# Change Notice

# GB & GW Series

## Changes to Location & Production for GB Pushbuttons & GW Rockers & Paddles

**Change Notices CN-0369 and CN-0369-A are both canceled and replaced by CN-0388.**

Changes for GB Pushbuttons & GW Rockers & Paddles

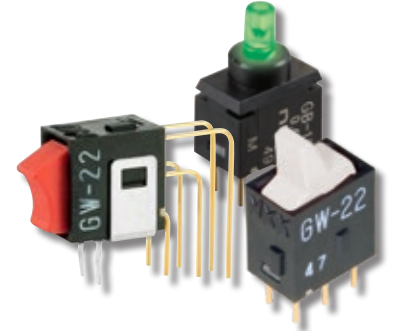
There will be revisions to the production and manufacture location for GB Pushbuttons and GW Rockers and Paddles, both illuminated and nonilluminated in each series. Previously, the lot code on the switch body had a dot mark above the first digit, but now the dot mark will be above the second digit. The shipping box for these pushbuttons, rockers or paddles had "CHINA FACTORY" on the side, but will be replaced with "PHILIPPINES FACTORY." These changes will apply to standard and custom GB Pushbuttons and GW Rockers. Effected standard part numbers for GB Series are below, and standard GW Series part numbers are on page 2.

Lot Number	Shipping Box
<b>Before Changes</b>	Dot Mark Above First Digit  Enlarged to Show Detail	 "CHINA FACTORY" printed on side of box
<b>After Changes</b>	Dot Mark Above Second Digit  Enlarged to Show Detail	 "PHILIPPINES FACTORY" printed on side of box

There are no changes to the switches' dimensions or specifications.  
 The location of the Lot Number on switch case may vary depending on the part number.  
 Contact the factory if more details are needed.
